City of Newton, Massachusetts
Department of Planning and Development
1000 Commonwealth Avenue Newton, Massachusetts 02459

PUBLIC HEARING/WORKING SESSION MEMORANDUM

SUBJECT: **#CP-25-1** WP East Acquisitions, requesting a Comprehensive Permit, pursuant to M.G.L. Chapter 40B to construct a 234-unit residential development on a 2.7 square acre lot located at 19 Court Street #1, 19 Court Street #2, 21 Court Street, 34 Crafts Street, 36 Crafts Street, 38 Crafts Street, 48 Crafts Street, and 50 Crafts Street within the Multi-Residence 1 (MR-1) and Manufacturing (M) zoning districts. The proposal includes 59 affordable units and 290 parking spaces.

Looking Northerly

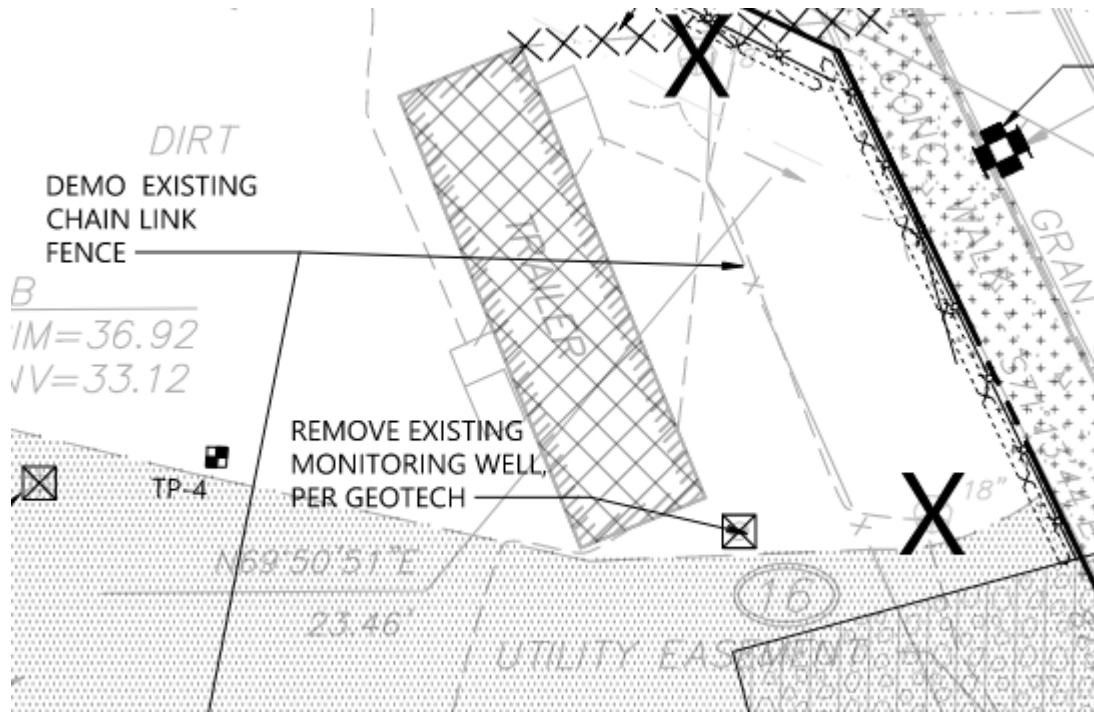
The site contains two City of Newton Drain Easements, the first is in a south to north orientation which has a 36" reinforced concrete pipe; and the second has a 36" x 48" box culvert that is in a west-east orientation on #50 Crafts St. The site plans do not indicate the actual location of the respective drain structures/conduits nor the limits of the recorded easements, these should be clearly identified on an existing conditions plan. The actual locations (alignment of both the box culvert & 36" drainpipe) will be required when the plans are updated; it imperative to accurately locate these as we have experienced the fact that sometimes pipes or culverts meander within and outside of the legal easement which may affect and impact the overall proposed design.
